Technical Bulletin: AirLink 5G band n41 connectivity issue

DATE ISSUED:	29-Mar-2023
ISSUED BY:	Sierra Wireless Enterprise Solutions Product Management
PRODUCTS AFFECTED:	XR80, XR90, MG90
VARIANTS AFFECTED:	XR80 5G North America XR90 5G North America MG90 5G Single-Radio North America
FOR DISTRIBUTION TO:	Affected Customers & Channel Partners
SUMMARY:	<p>We are investigating an issue where North American MG90 5G single-radio and XR80/90 5G North American routers may experience <u>permanent and irreversible</u> connectivity issues on 5G band n41 used by T-Mobile and Rogers.</p> <p>This bulletin provides steps that our customers using PRODUCTS AFFECTED on T-Mobile and Rogers <u>must take</u> to ensure their routers remain operable until new firmware is released.</p> <p>The details are:</p> <ul style="list-style-type: none"> • 5G band n41 is used by T-Mobile and Rogers, therefore this issue only impacts 5G routers operating on T-Mobile and Rogers. • n41 may experience <u>permanent and irreversible damage</u>. The occurrence of the issue can be prevented by following the steps in the bulletin. <p>The following scenarios are NOT affected:</p> <ul style="list-style-type: none"> • Routers

Cellular WAN Link Configuration
(Sierra Wireless EM919X @ MiniCard USB3 CA (Cellular A))

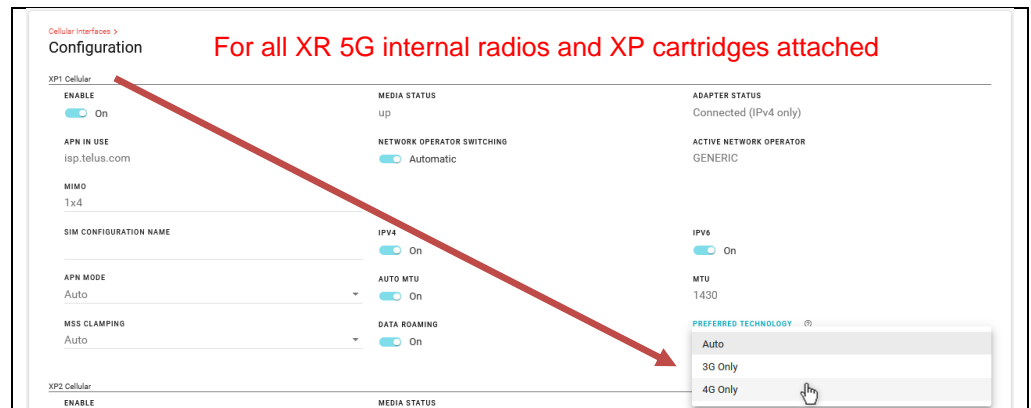
GUIDANCE FOR MG90 CUSTOMERS:

Only North American MG90 5G single-radio routers operating on 5G T-Mobile and Rogers are affected.

- North American MG90 5G dual-radio routers are not impacted.
- For MG90 **PRODUCTS AFFECTED**, disable n41 now (see below) by adding "41" in the text input field
- An MGOS update that deploys updated radio module firmware will be available in May 2023.

Setting for Band

Custom Band Setting Mode comma-separated bands
